**Moorhead Area Public Schools
Grades 5-6 Addition at Horizon Campus
Moorhead, MN**

**Project No. 15-024
Date: April 1, 2015**

ADDENDUM NUMBER 2

Drawing A3.10 - FIRST LEVEL FLOOR PLAN – AREA "A"

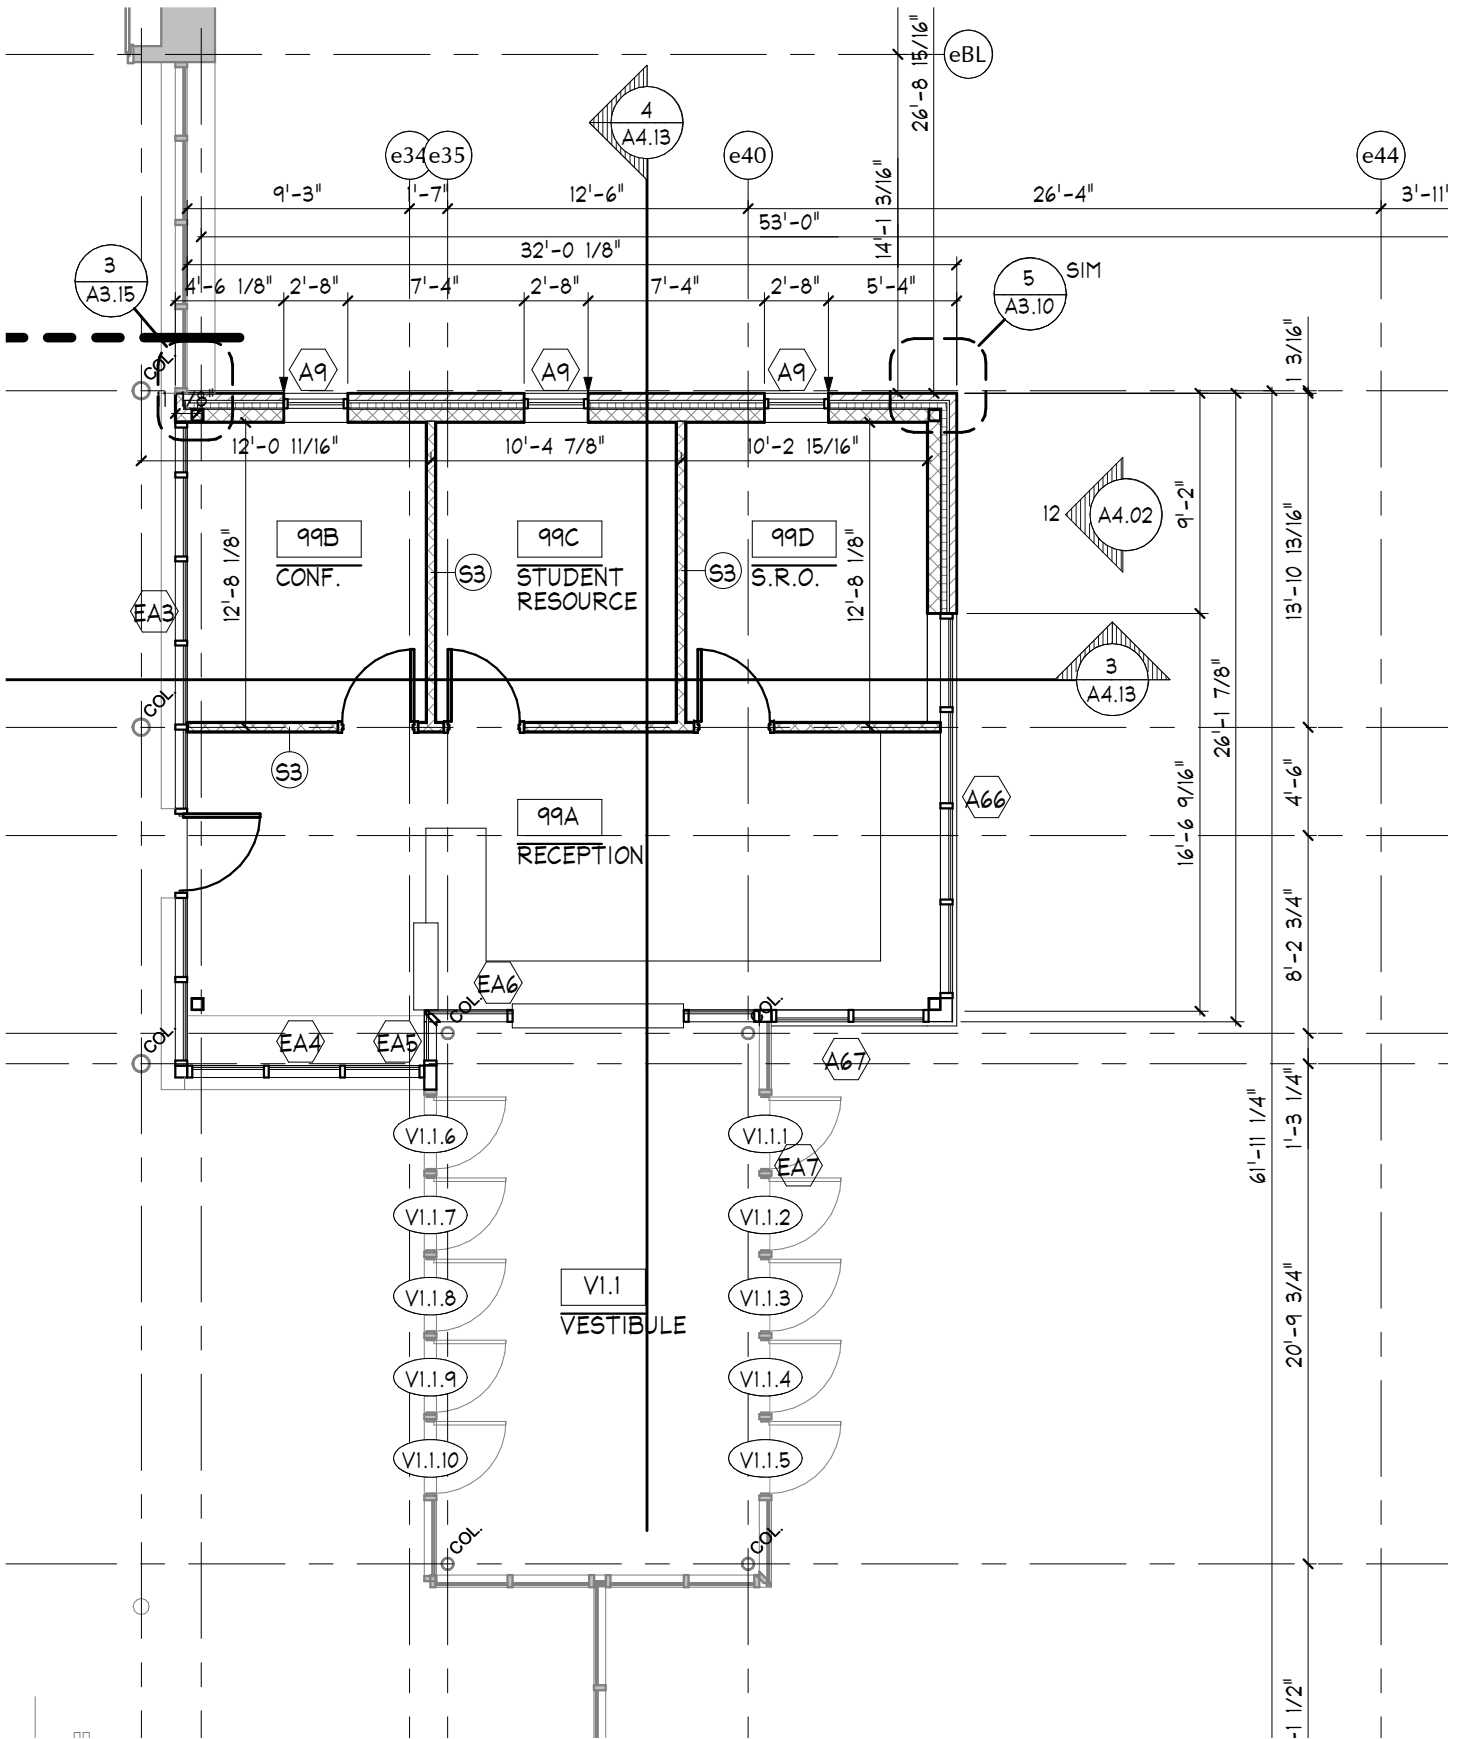
1. Detail 1 First Level Floor Plan - Area A: M4 block walls under stair S5C to have wall pattern P1.
2. Detail 1 First Level Floor Plan - Area A: Provide 1 hour rated GWB ceiling under stair S5C.
3. Detail 1 First Level Floor Plan - Area A: S3 stud wall under stair S5B to be M4 block walls with wall pattern P1.
4. Detail 1 First Level Floor Plan - Area A: Provide 1 hour rated GWB ceiling under stair S5B.
5. Detail 1 First Level Floor Plan - Area A: Change the interior aluminum frame designation of A-38 on the south wall of Rooms 568 & 596 to A-22.
6. Detail 1 First Level Floor Plan - Area A: Change the exterior aluminum frame designation of A-8 between Rooms 565 & 566, on building elevation 10/A4.02 to A-41.

Drawing A3.11 - FIRST LEVEL FLOOR PLAN – AREA "B"

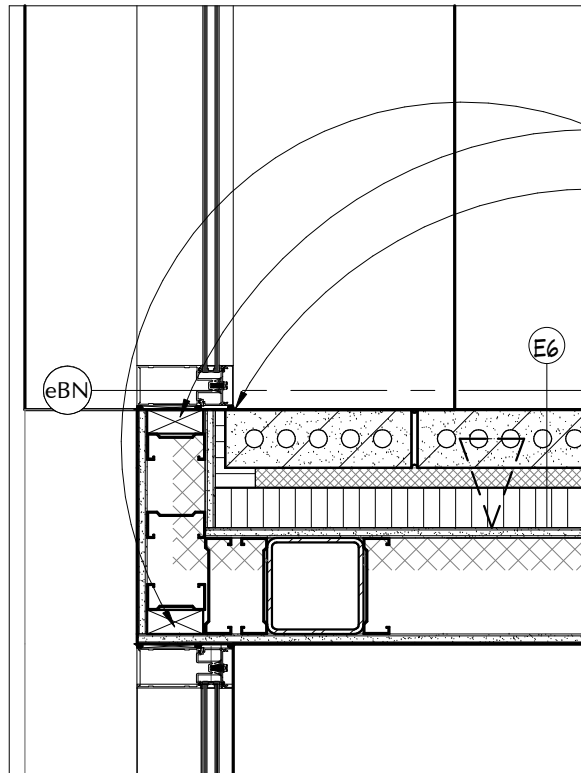
1. Detail 1 First Level Floor Plan - Area B: In room Boys and Girls, 513, 514, 525, 526 the north M8 block wall is to have wall pattern P2, changed from wall pattern P1.

2. Detail 1 First Level Floor Plan - Area B: S3 stud wall under stair S5E to be M4 block walls with wall pattern P1.
3. Detail 1 First Level Floor Plan - Area B: Provide 1 hour rated GWB ceiling under stair S5E.

4. Detail 1 First Level Floor Plan - Area B: S3 stud wall under stair S5D to be M4 block walls with wall pattern P1.
5. Detail 1 First Level Floor Plan - Area B: Provide 1 hour rated GWB ceiling under stair S5D.

6. Detail 13 Enlarged Drinking Fountain Plan: All S3 stud walls that are adjacent to the drinking fountains should have wall pattern P4.
7. Detail 14 Enlarged Staff Toilet Plan: All S2 and S3 stud walls should have wall pattern P4 on the toilet room side.

8. Detail 15 Enlarged Staff Toilet/ Elec Plan: All S2 and S3 stud walls should have wall pattern P4 on the toilet room side.
